DOMETIC HEATING FURNACES

Furnace Limit Switch Service Bulletin

Model	Serial Number Range
All Small & Medium Furnaces (AFS, AFM, DFS, DFM)	73985322 – 81099541

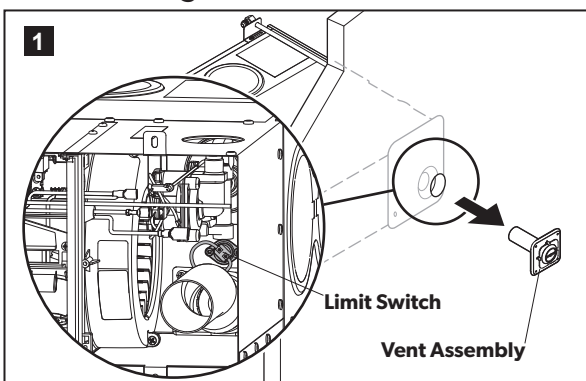
The cause of this nuisance issue is a mistaken omission of a plastic wire tie to suspend the heat exchanger limit switch wires up and away from the exhaust tube vent terminal. The omission of this component allows the limit switch wires to potentially melt on the vent terminal, shorting to ground, and causing either the fuse or circuit breaker in the circuit to blow, or the sail switch to become inoperative. **In ALL cases the safety devices in the system are performing as designed and prevent the furnace from operating.**

After removing the vent assembly, look into the exhaust vent tube area. If visual evidence exists that the limit switch wires are melted or laying on the exhaust vent tube, contact the Dometic Technical Service department at 866-869-3118 to obtain authorization for removal of the furnace for replacement, prior to repairing any wires or continuing with a field repair. The field repair involves sliding a 7" long, high-temperature rated, fiberglass sleeve over the exhaust tube. The field repair kit became available in March, 2018. The field repair kit part # is 31389, Flat Rate Time is .5 and the fault code is 617.25.
